CUY-237-06.95

REPLACEMENT OF THE SUPERSTRUCTURE OF CUY-237-0695 (SFN 1810286), OVER SNOW ROAD, AS WELL AS APPROACH PAVEMENT REPLACEMENT.

≥	NUMBER	DATE	DESCRIPTION
ADDENDU	\triangle	11/26/2024	REVISED NOTE & ADDED CONST. DRAWING
l

P. 3 120

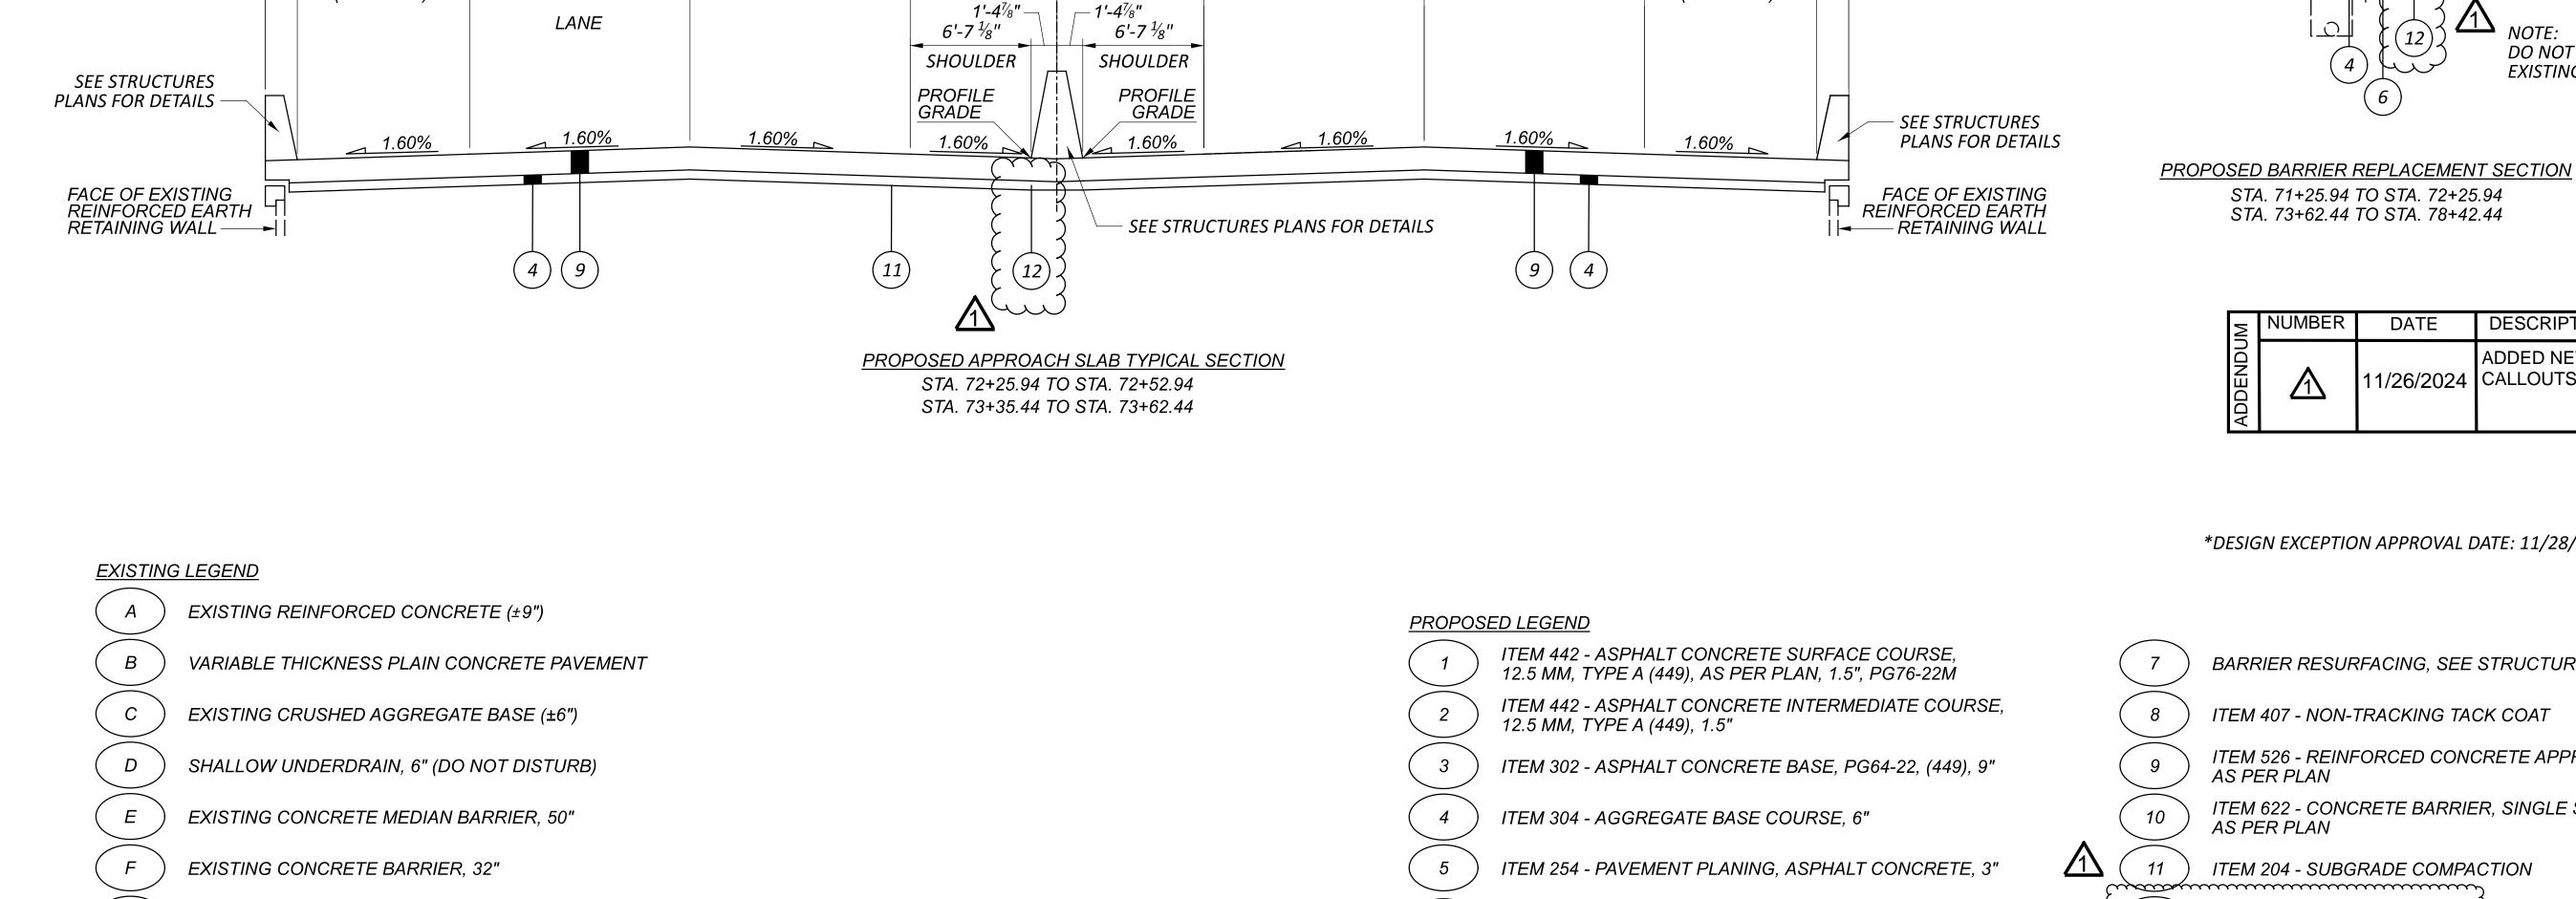
≥	NUMBER	DATE	DESCRIPTION
ENDU	Λ	11/26/2024	ADDED NEW CALLOUTS
